Access Compliance Report

Public Rights-of-Way

Intersection ID: 17333	Main Street: AUTUMN_RAIN_LN	Cross Street: CONSTABLE_CT	Location: NW
ADA ID: AB83E1FF5374	Ramp Type: PerpDiag	Initial Pass/Fail: Fail	Overall Compliance: No
Codes/Mitigation Info/Possible Solution		Field Measurements/Component Compliance

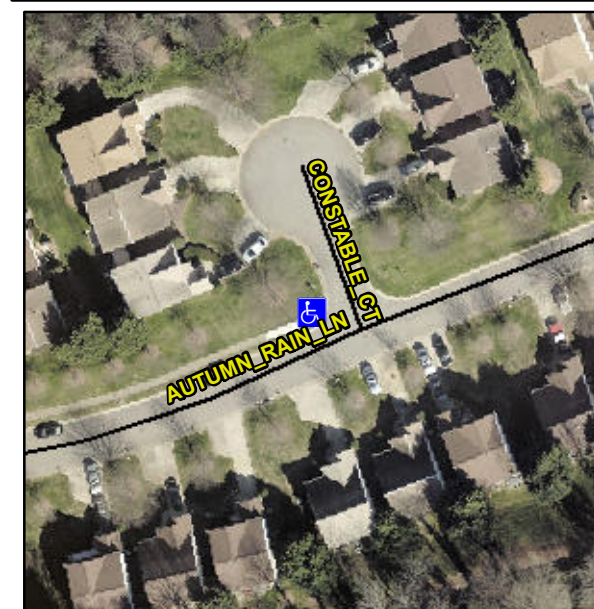
Not Found, R304.2.2, R304.5.3

Compliance	Description	Data	Compliance	Description	Data
N/A	Ramp Length (in)	49.0	No	Ramp Slope (%)	11.2
Yes	Ramp Width (in)	48.0	No	Ramp XSlope (%)	4.3
N/A	Flare Type LT	N/A	N/A	Flare Type RT	N/A
N/A	Flare Slope LT (%)	N/A	N/A	Flare Slope RT (%)	N/A
N/A	Flare Traversable LT?	N/A	N/A	Flare Traversable RT?	N/A
N/A	Landing Length (in)	N/A	N/A	DWS Provided?	N/A
N/A	Landing Width (in)	N/A	N/A	DWS Contrast?	N/A
N/A	Landing Slope (%)	N/A	N/A	DWS Length (in)	N/A
N/A	Landing X Slope (%)	N/A	N/A	DWS Full Width?	N/A
N/A	Landing Curb? (Y/N)	N/A	N/A	DWS Offset (in)	N/A
N/A	Shared Landing?	N/A			
N/A	Gutter Ponding?	N/A	N/A	Gutter Slope (%)	N/A
N/A	Gutter Lip Ht (in)	N/A	N/A	Gutter X Slope (%)	N/A
N/A	Painted X Walk1?	No	N/A	Painted X Walk2?	No
	X Walk 1 Direction	To S		X Walk 2 Direction	To E
N/A	X Walk 1 Width (in)	N/A	N/A	X Walk 2 Width (in)	N/A
	X Walk 1 Slope (%)	3.1		X Walk 2 Slope (%)	4.7
	X Walk 1 X Slope (%)	4.6		X Walk 2 X Slope (%)	1.3

Remove & Replace Curb Ramp With Two New Directional Ramps or Equivalent.
